Our reference: 2022/4303/PRE

Re: 2 Old Court House, North End Way, London, NW3 7ER

Proposed works: Proposed mansard roof extension with roof lantern, inset roof terrace to the rear and associated glass balustrade. Installation of 2 air conditioning units at the newly created third floor level.

Figure A (above): Photograph of the site in 1938 – (source: Britain from Above (Britain From Above)

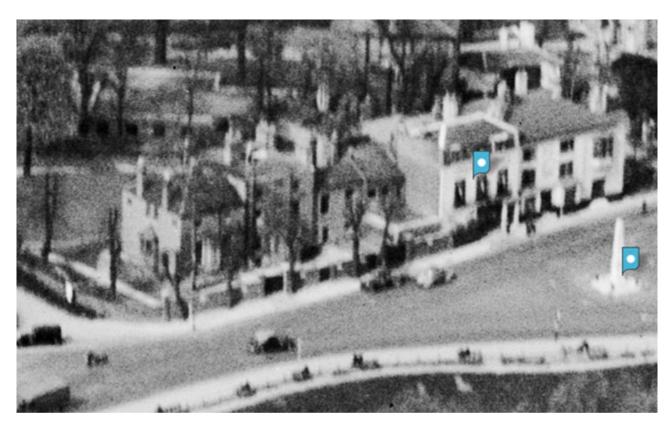
The building currently has a flat roof which is clearly legible from the street with the large chimney stacks rising above. Figure A, below, is an aerial photograph taken in 1938, and although not perfectly legible it is clear there is no mansard roof form, the chimneys are particularly prominent, rising high above the historic, low-rise roofslope.

Circa 1933Figure B (above): An artist's impression of the site as provided by the applicant – (source: unspecified)

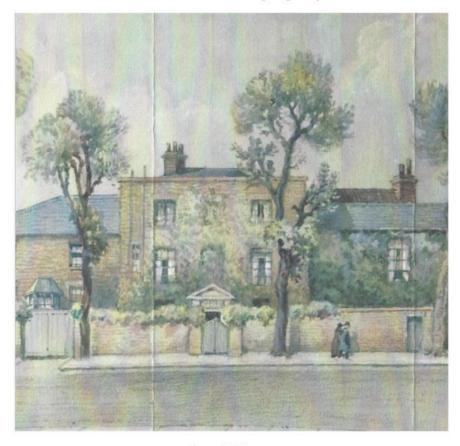
The painting shown below in Figure B shows a low-pitched roof inside the parapet wall. This traditional roof arrangement would have been designed to assist rainwater egress from the roof and not to provide additional accommodation within the roof space. The property is not considered to have had roof-level accommodation in the past, nor be of an architectural style that is appropriate for a mansard roof structure. Given the history of the listed building, as never having roof level accommodation, it is considered unacceptable in principle on this Grade II Listed building.
